CITY OF MANHATTAN BEACH
COMMUNITY DEVELOPMENT DEPARTMENT

801 North Sepulveda Blvd.

Subject: Appeal of Paragon Project Resolution No. PC 17-01, Summary

EXHIBIT 15.

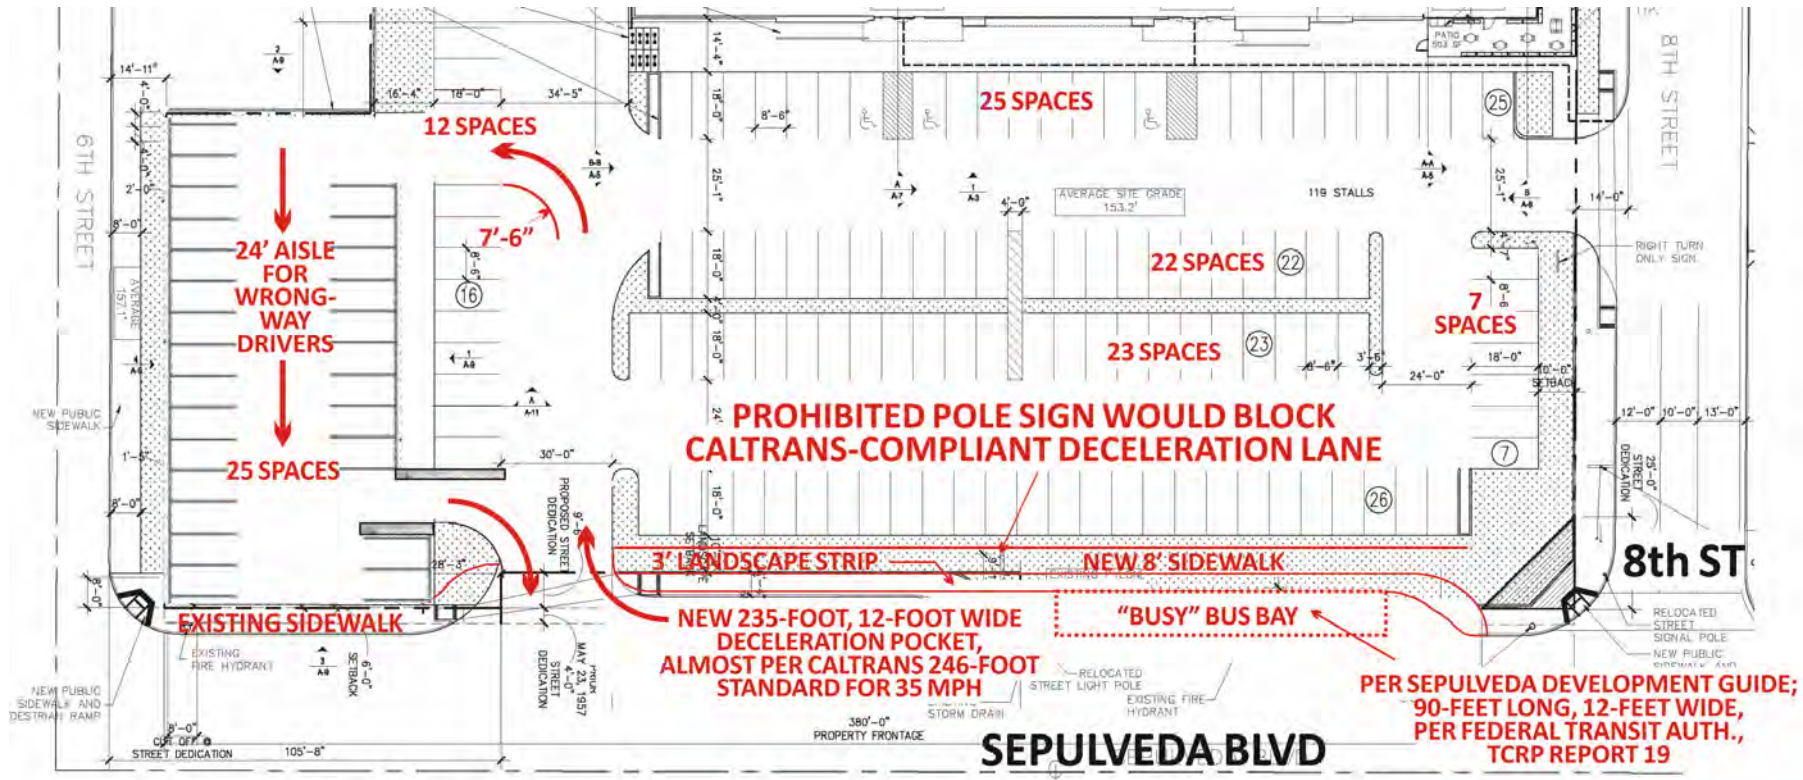
Exhibit 15 illustrates a deceleration lane that complies with CEQA Guidelines, Caltrans standards and the city Sepulveda Guide. The design also incorporates conditions added by Commissioner Conaway, for an eight-foot sidewalk and a three-foot landscaped shoulder.

DELETE BANKING INVESTMENT CENTER FOR COMPLIANT PARKING AND DECELERATION LANE
